STAFF REPORT

CONCERNING APPLICATION FOR A CERTIFICATE OF APPROPRIATENESS

Application Number: 2019-0603C

Property Location: 417 W Navarre Avenue

(BACK OF HOUSE)
NORTH SIDE

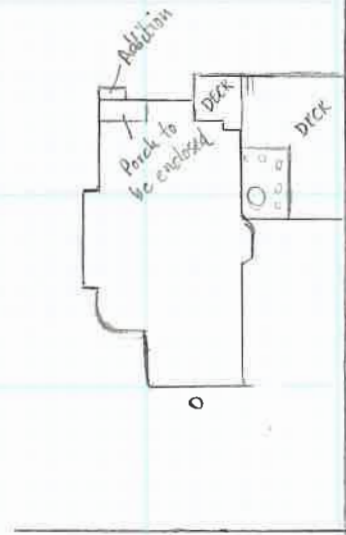
HPC STAFF NOTE: PRELIMINARY DRAWING, NOT AS PROPOSED

WEST SIDE

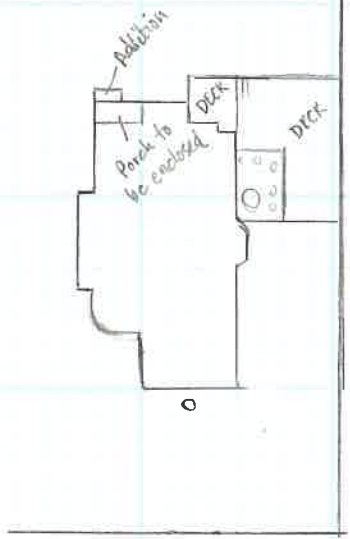
HPC STAFF NOTE: PRELIMINARY DRAWING, NOT AS PROPOSED
